Norfolk Vanguard Offshore Wind Farm

Statement of Common Ground

Highways England

Applicant: Norfolk Vanguard Limited
Document Reference: REP1-SOCG-7.1

Figure:	2	Drawing No:	PB4476-003-00X-002			
Revision:	Date:	Drawn:	Checked:	Size:	Scale:	
01	12/01/2018	GC	RE	A3	1:10,000

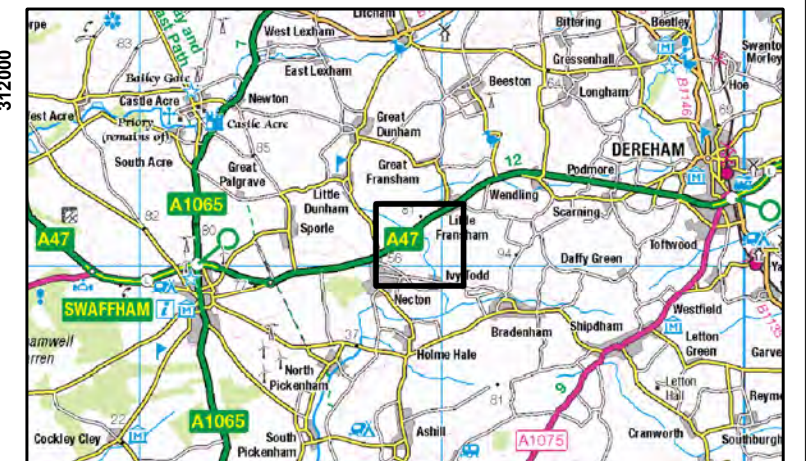
8. RHDHV have since explained that two substation accesses, to the south of the A47, are required. The existing access would be used for construction traffic relating to the extension of the existing National Grid substation and another access would be needed for the construction of the offshore substation for the Norfolk Vanguard Wind Farm. Access options A, A1 and B have been considered as presented in drawing no. PB4476-003-00X-002 of the A47 Access TN.

18. Highways England will require scale plans of the proposed Access A/A1 and Access B junction layouts (with dimensions and visibility splays shown) before agreeing to the proposals in principle. Any agreement would also be subject to acceptance by NCC and a Stage 1 Road Safety Audit.
19. If Access A is progressed, Highways England would require the temporary traffic management strategy or construction management plan for review and an assessment of the impact of u-turning traffic on the A47/ A1075 junction at Dereham.

20. As part of the proposed National Grid substation extension, RHDHV have advised that access to a field containing an electricity pylon to the north of the A47 (off the eastbound carriageway) will be required for overhead line modification works. The A47 Access TN explains that these works will comprise two construction peaks, each lasting one week with a gap of 4-6 months between each peak. During the construction peaks a total of 48 vehicle movements a day (40 HGVs and 8 light vehicles) have been forecast. Access options C, D and D1 have been considered as presented in drawing no. PB4476-003-00X-002 of the A47 Access TN.
